**Kensington Aldridge Academy,
London W10**

Fire Safety Review

Job Number: 1103

June 2018

Figure 1 – Section through main external wall type

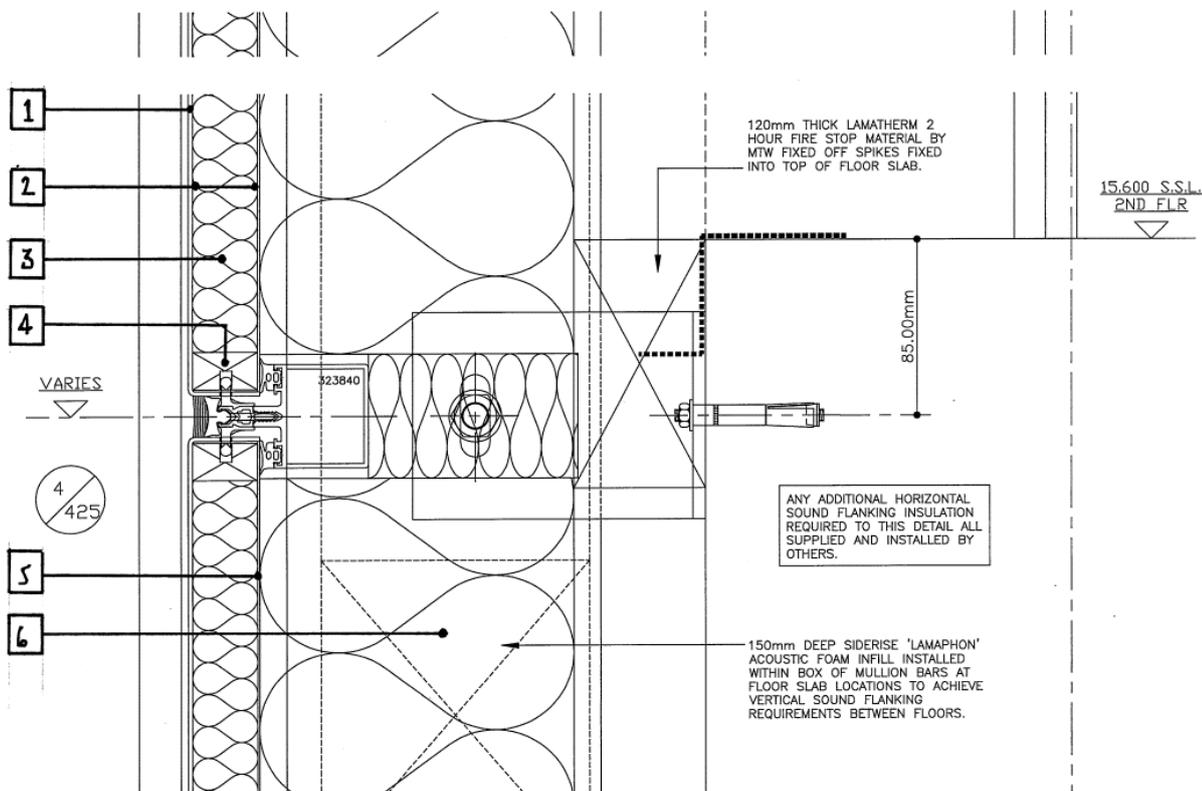
3.0.1 The building structure comprises a reinforced concrete frame and floors. The external walls are lined internally with plasterboard sheets and externally with a proprietary ACM panel as shown in Figure 1 below. The rest of the external wall specification is confirmed below.

3.0.2 The perimeter of the ACM panels are machine with 80 mm long slots to allow the panels to be fixed using a Schuco retaining toggle. The joints between the panels are sealed with a resilient flexible sealant and cavity barriers are closed state (i.e. no ventilation openings) therefore it as an unventilated rainscreen cladding system.

Figure 2 – Lower ground floor level

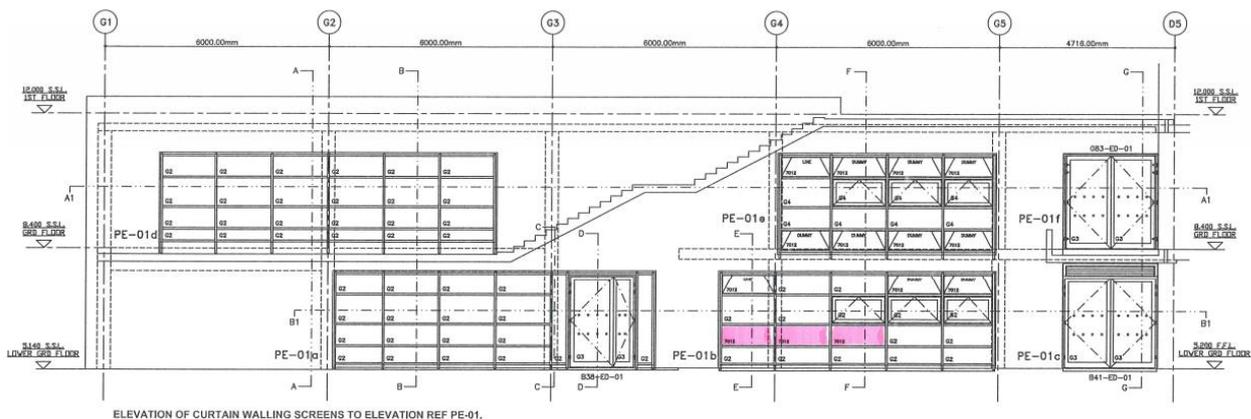
3.0.3 As an alternative to the specification shown above, Kingspan K15 insulation (phenolic foam with a Class C-s1, d0 reaction to fire) is used instead of Rockwool for acoustic reasons. This alternative specification relates to three panels in one room at lower ground floor level (see Figure 2) and seven classrooms at ground floor level (see Figures 3 and 4) as highlighted in pink.
